Access Compliance Report

Public Rights-of-Way

(Curb Ramps)

Intersection ID: 42943	Main Street: LONG_PAW_LN	Cross Street: SONOMA_VALLEY_DR	Location: E
ADA ID: 846AADCC1C93	Ramp Type: PerpDiag	Initial Pass/Fail: Fail	Overall Compliance: No
		Severity Score: 10

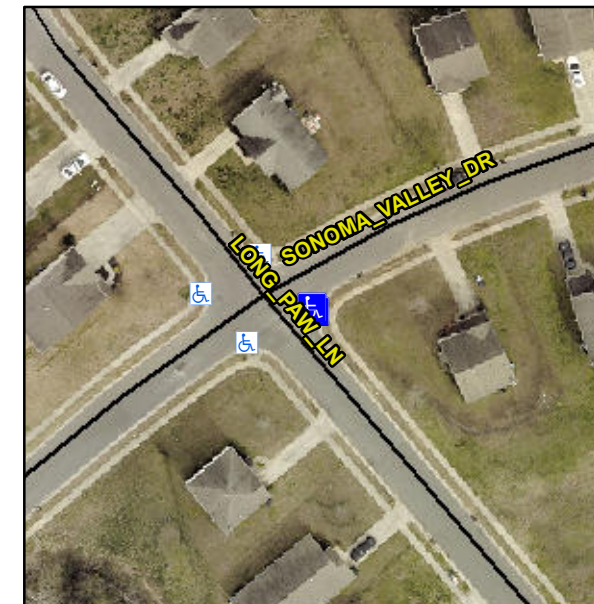
Not Found, R304.5.1, R304.5.3

Compliance	Description	Data	Compliance	Description	Data
N/A	Ramp Length (in)	50.5	Yes	Ramp Slope (%)	8.0
No	Ramp Width (in)	47.0	No	Ramp XSlope (%)	2.9
N/A	Flare Type LT	N/A	N/A	Flare Type RT	N/A
N/A	Flare Slope LT (%)	N/A	N/A	Flare Slope RT (%)	N/A
N/A	Flare Traversable LT?	N/A	N/A	Flare Traversable RT?	N/A
N/A	Landing Length (in)	N/A	N/A	DWS Provided?	N/A
N/A	Landing Width (in)	N/A	N/A	DWS Contrast?	N/A
N/A	Landing Slope (%)	N/A	N/A	DWS Length (in)	N/A
N/A	Landing X Slope (%)	N/A	N/A	DWS Full Width?	N/A
N/A	Landing Curb? (Y/N)	N/A	N/A	DWS Offset (in)	N/A
N/A	Shared Landing?	N/A			
N/A	Gutter Ponding?	N/A	N/A	Gutter Slope (%)	N/A
N/A	Gutter Lip Ht (in)	N/A	N/A	Gutter X Slope (%)	N/A
N/A	Painted X Walk1?	No	N/A	Painted X Walk2?	No
	X Walk 1 Direction	To NW		X Walk 2 Direction	To SW
N/A	X Walk 1 Width (in)	N/A	N/A	X Walk 2 Width (in)	N/A
	X Walk 1 Slope (%)	0.1		X Walk 2 Slope (%)	6.0
	X Walk 1 X Slope (%)	1.1		X Walk 2 X Slope (%)	2.0

Remove & Replace Curb Ramp With Two New Directional Ramps or Equivalent.
